Amendments to the Drawings

REMARKS**Statement of Substance of Interview**

FIG. 6

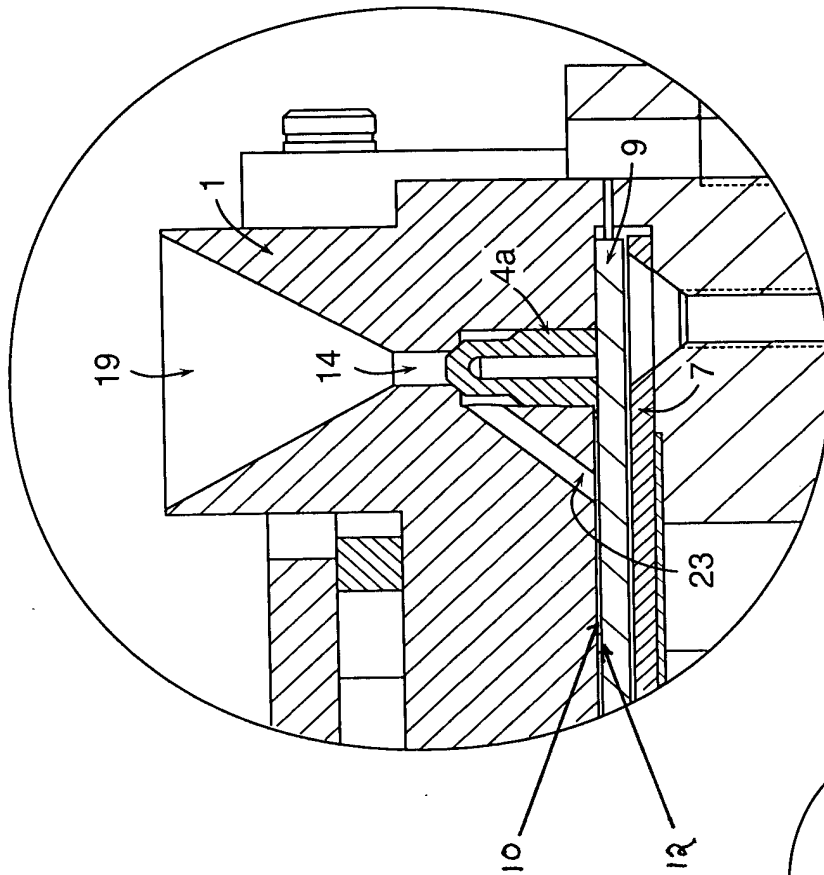
In Figure 6, reference numerals 10 and 12 have been added from Figure 7.

FIG. 10

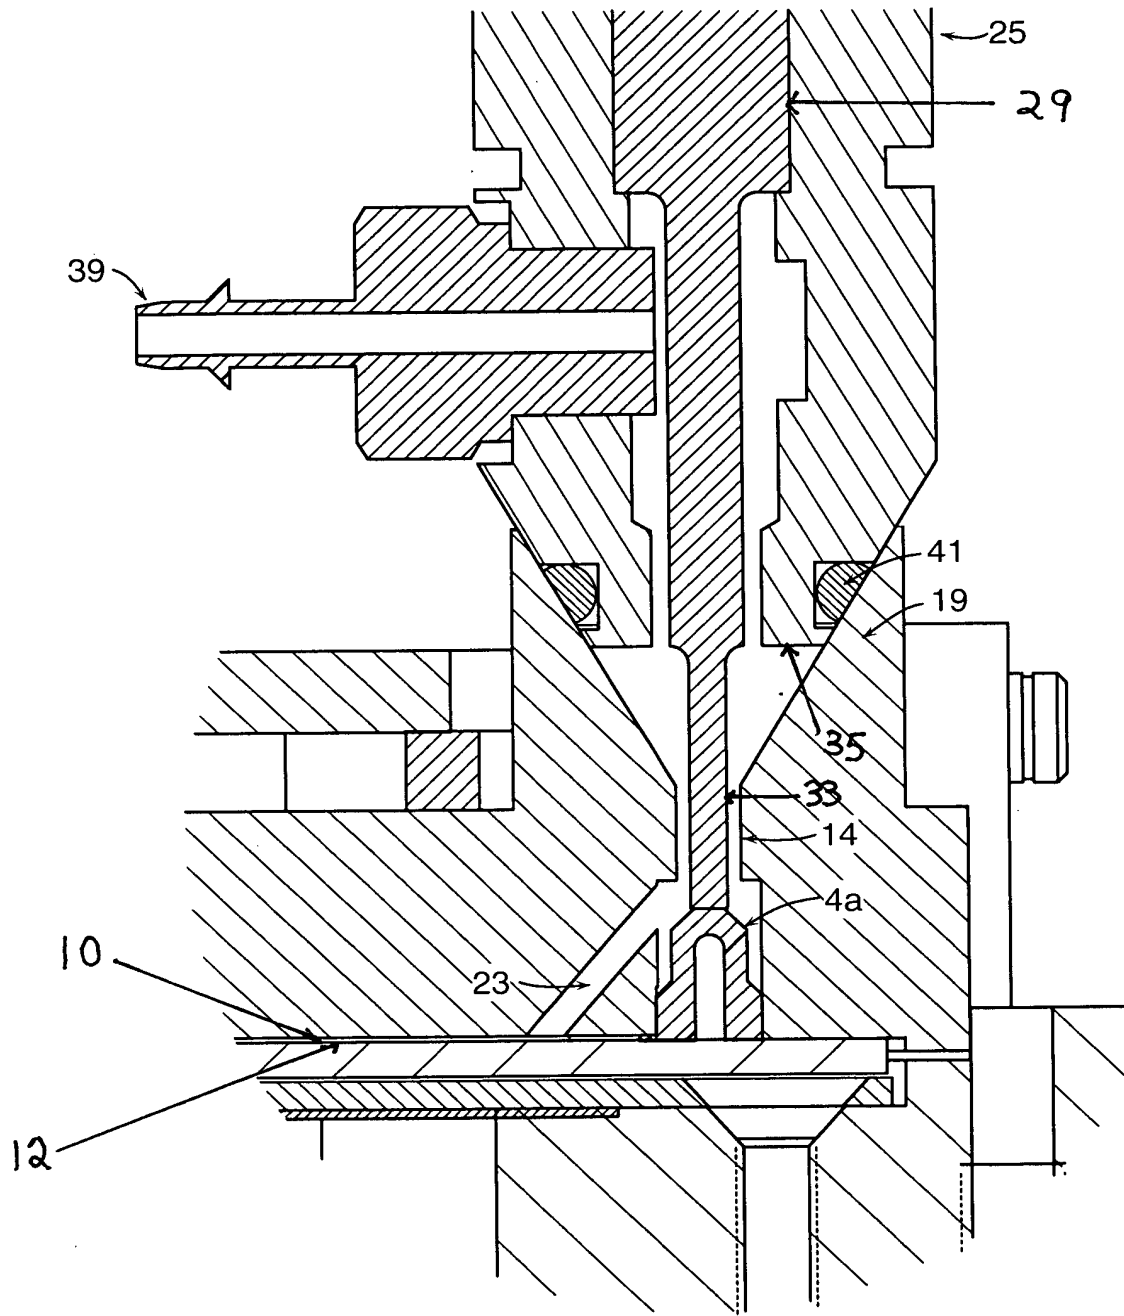
In Figure 10, reference numerals 29, 33 and 35 have been added from Figure 9 and reference numerals 10 and 12 have been added from Figure 7.
